STATE OF VERMONT AGENCY OF TRANSPORTATION

PROPOSED IMPROVEMENT BRIDGE PROJECT TOWN OF HARTLAND COUNTY OF WINDSOR

RECORD PLANS	
CONTRACTOR:	KUBRICKY CONSTRUCTION CORP. - WILTON, NY
RESIDENT ENGINEER:	DARYL BASSETT
CONSTRUCTION BEGAN:	JUNE 10, 2014
CONSTRUCTION COMPLETE:	NOVEMBER 5, 2014
RECORD PLANS BY:	DARYL BASSETT & KEVIN KING
I HEREBY CERTIFY THAT ALL THE CONSTRUCTION REQUIRED BY THIS SET OF DRAWINGS HAS BEEN ACCOMPLISHED AS INDICATED HEREIN.	
BY	RESIDENT ENGINEER
DATE	2/22/16
NOTE: Any further information concerning final quantities, amounts or other details relative to this project may be found by contacting Vtrans Records Management.

US ROUTE 5 (MAJOR COLLECTOR), BRIDGE NUMBERS 62A AND 66

SPECIAL PROVISION (RETAINING WALL)
 N. T. S.

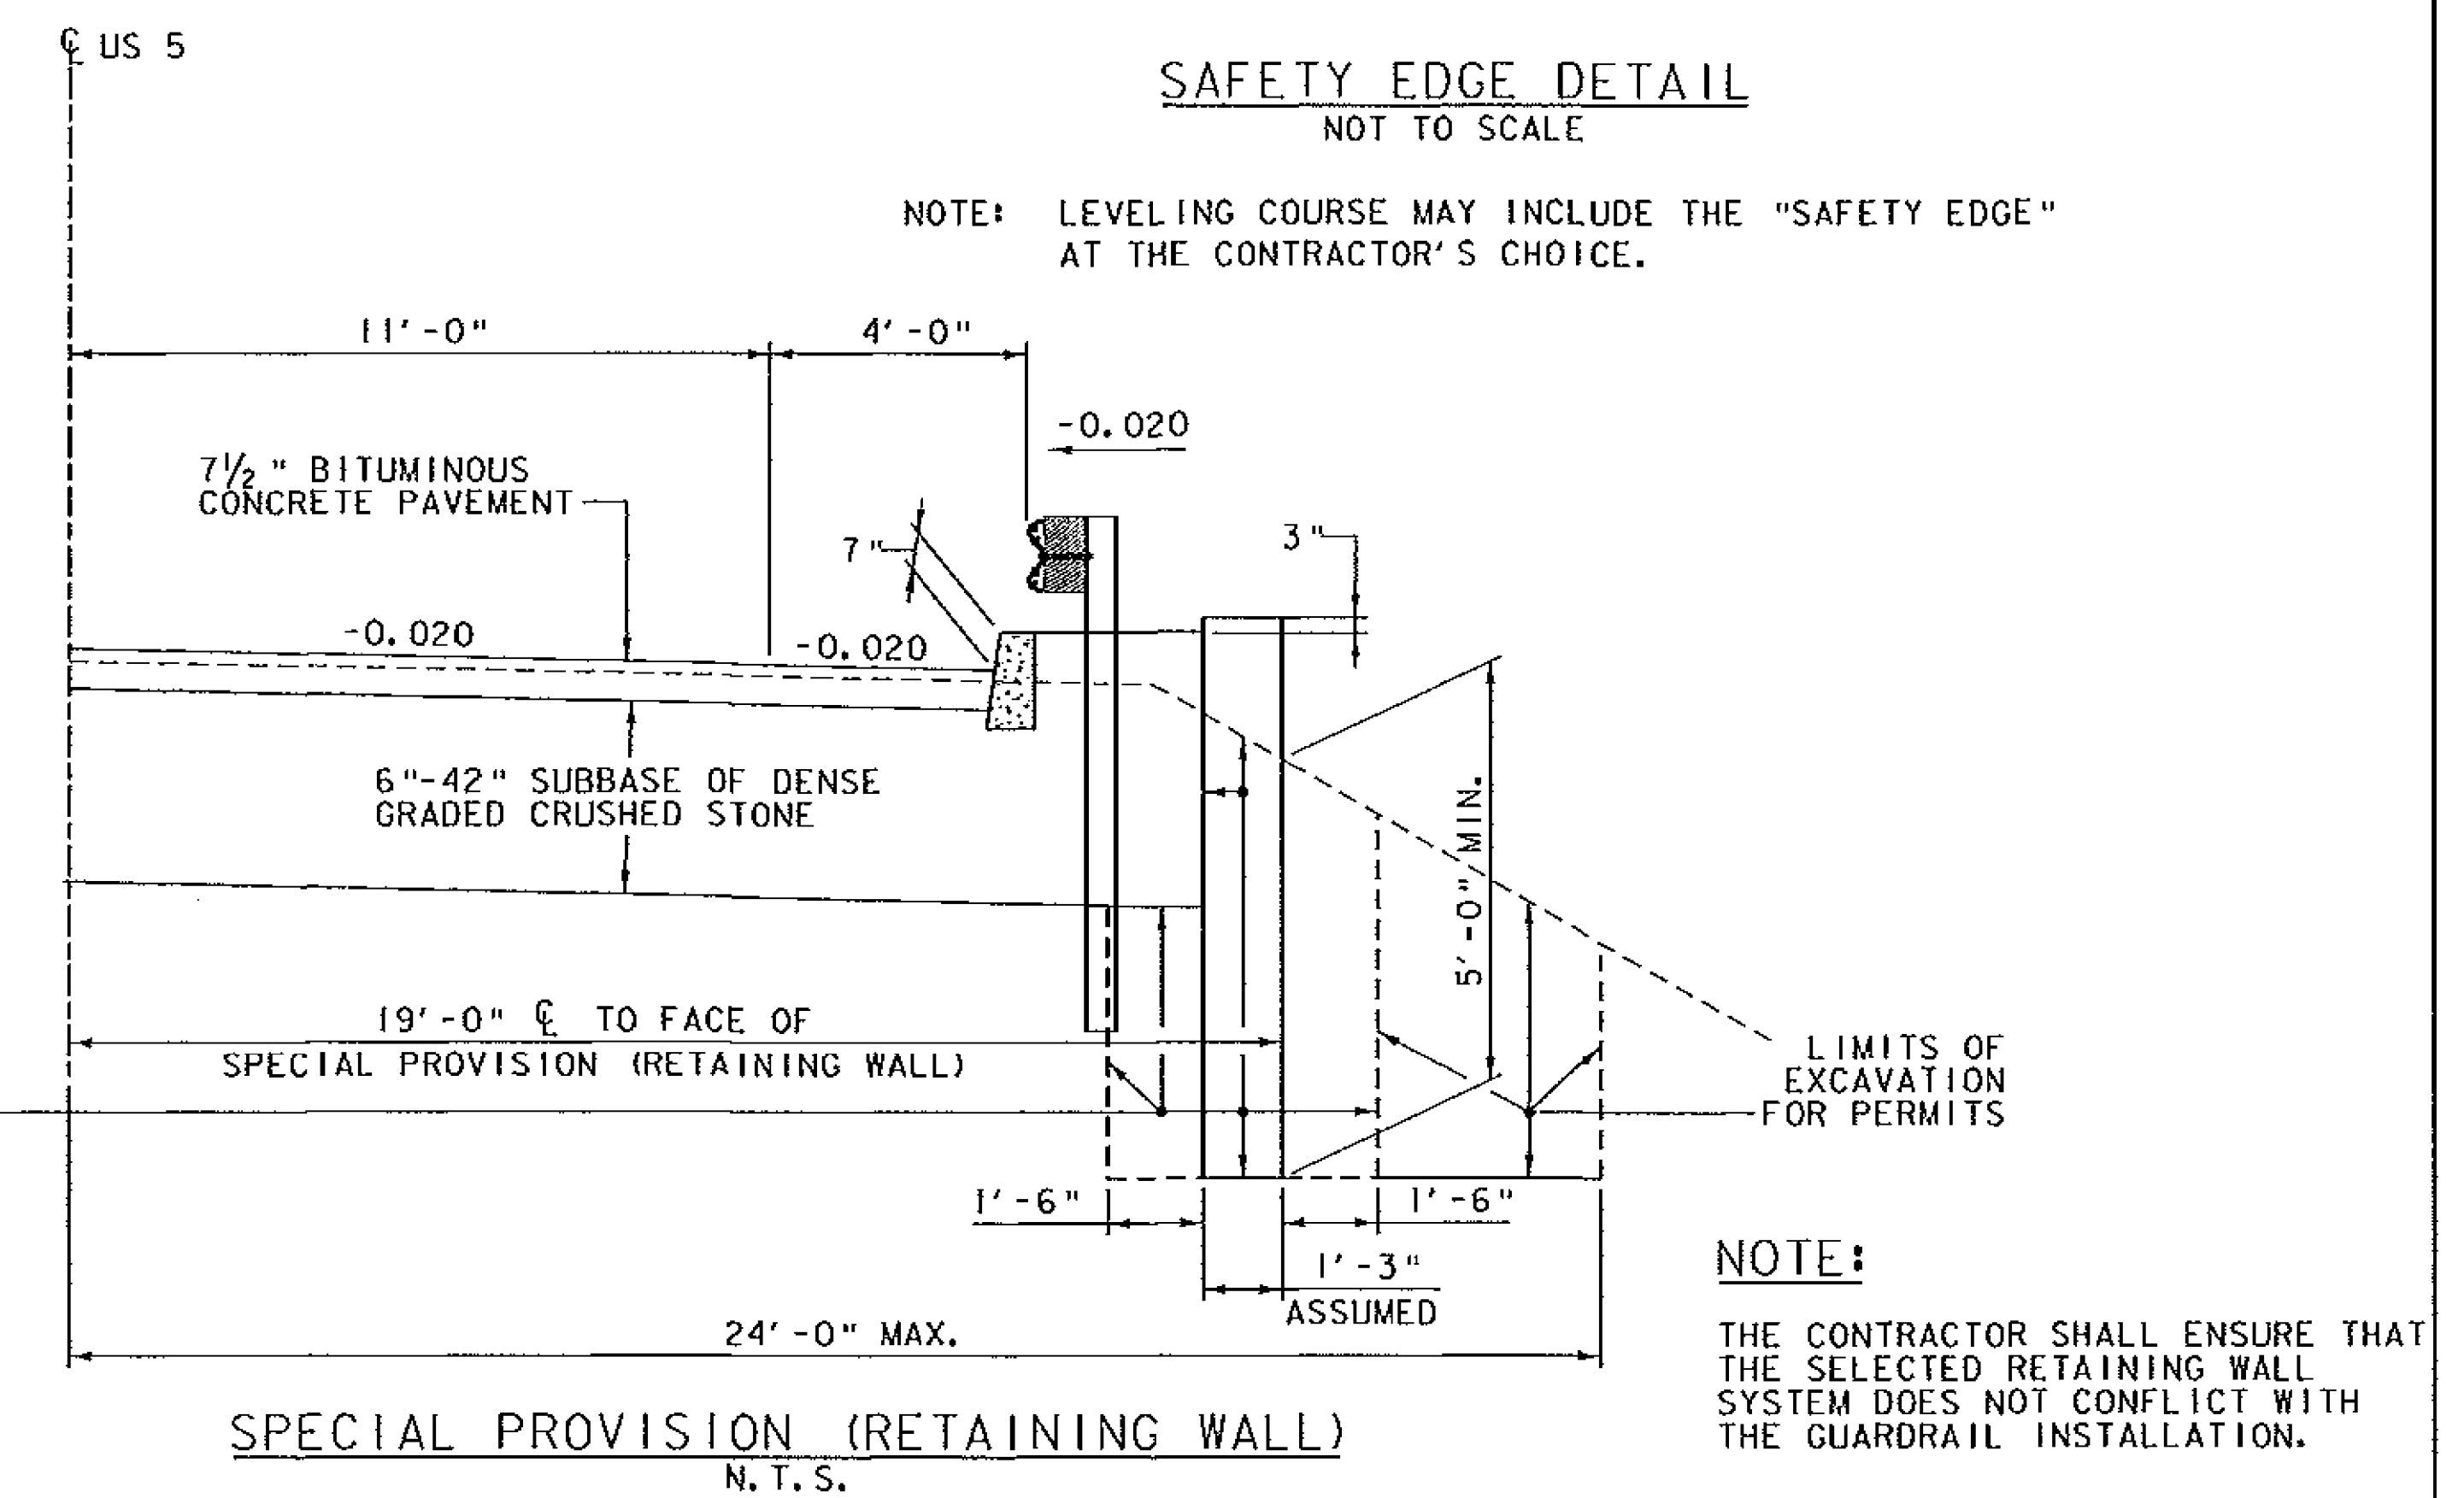
REV.	DESCRIPTION	DATE
△	REMOVED THE WORD "SHOULDER"	3/3/2014

FILE NAME: zllc260dallgn.dgn	PLOT DATE: 2/12/2014
PROJECT LEADER: M.A. COLGAN	DRAWN BY: M.C. SCOTT
DESIGNED BY: M.C. SCOTT	CHECKED BY: S.E. BURBANK
BR 62A ALIGNMENT LAYOUT PLAN	SHEET 11 OF 55

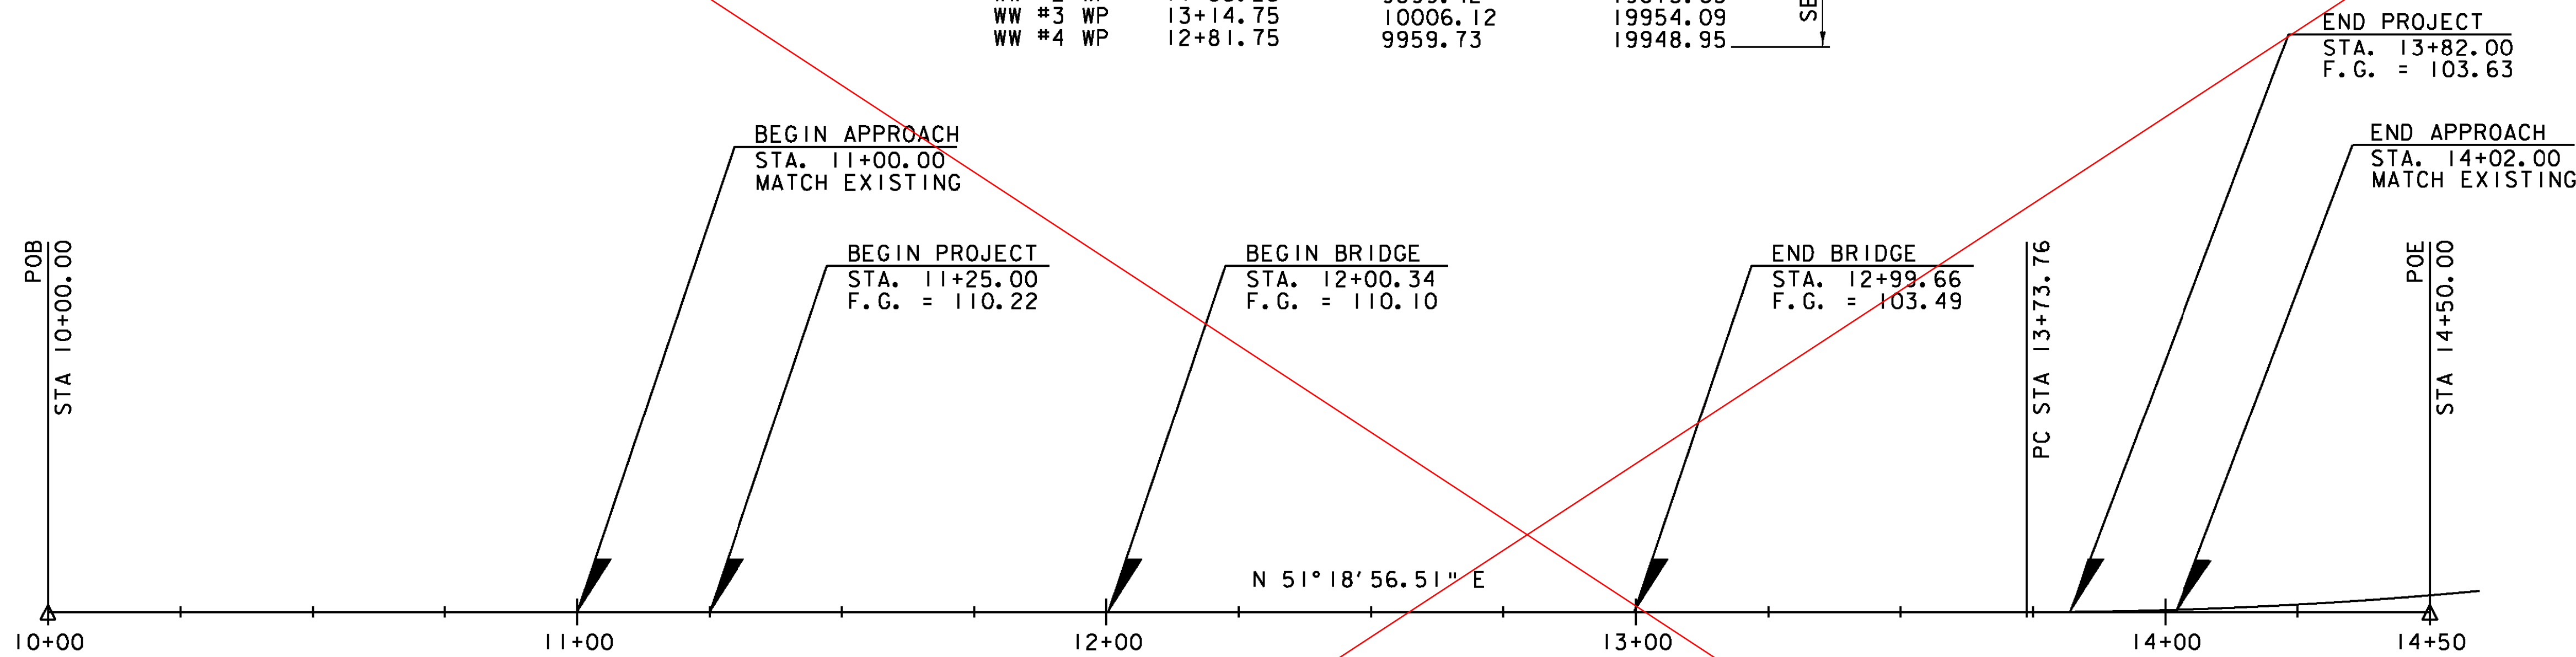
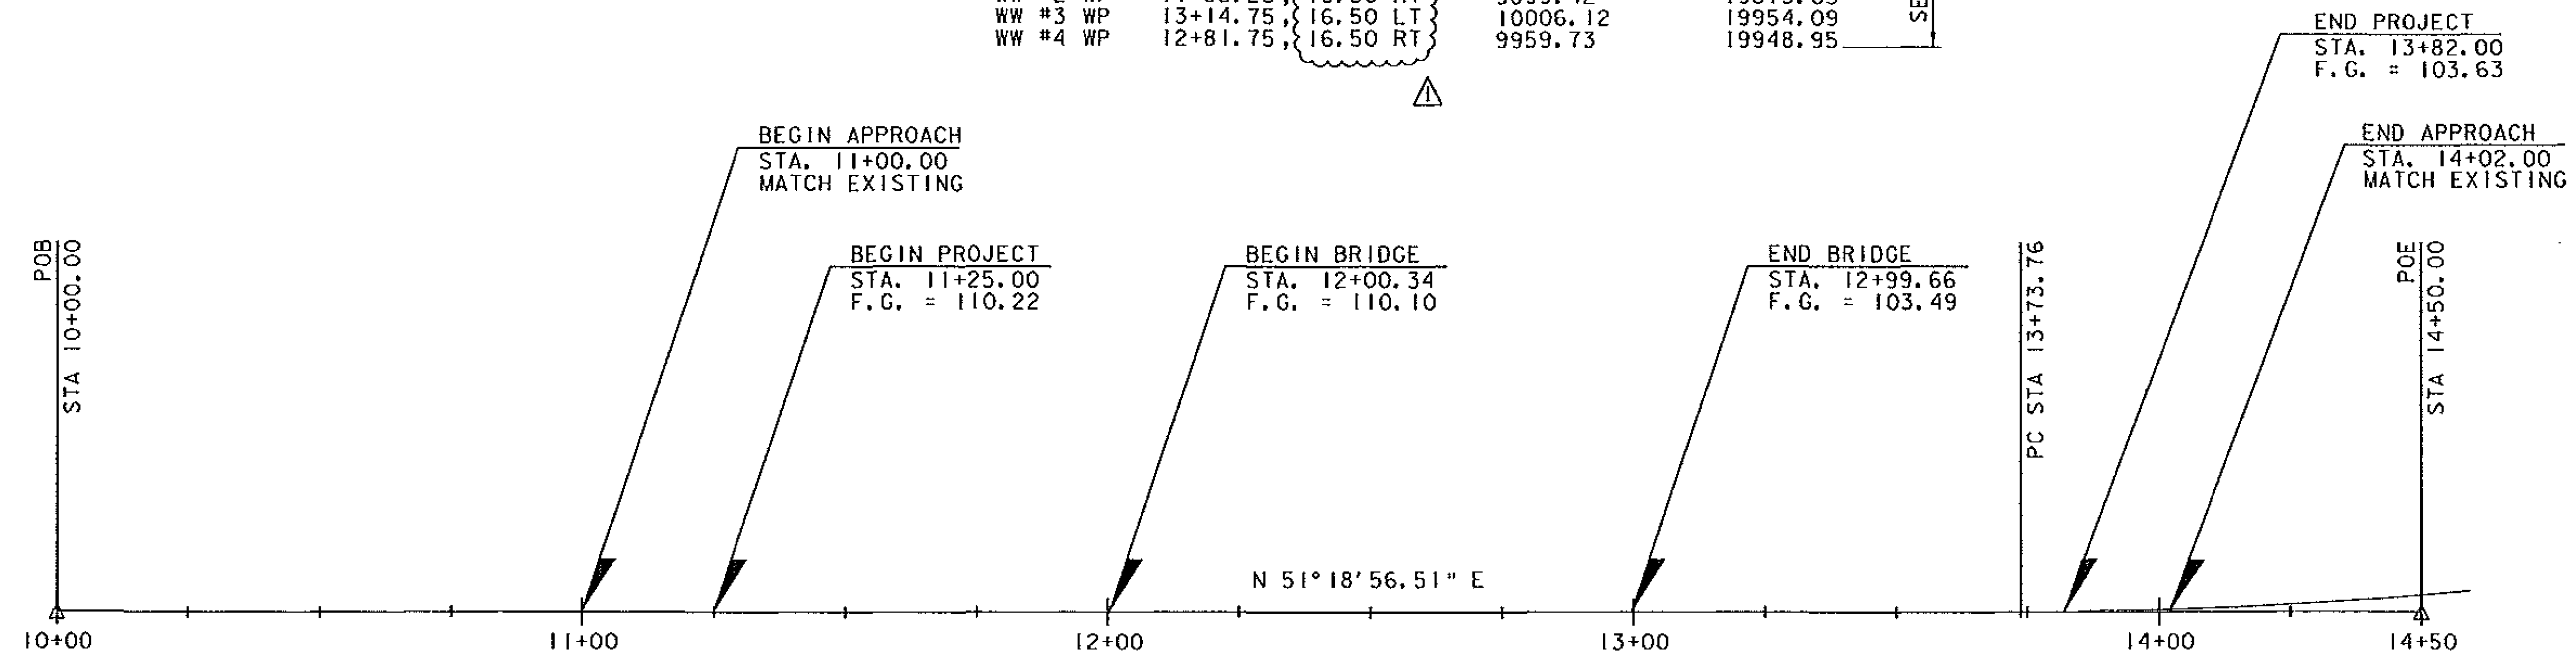
REV.	DESCRIPTION	DATE
△	CORRECTED COORDINATE & ADDED WP OFFSETS	2/12/2014
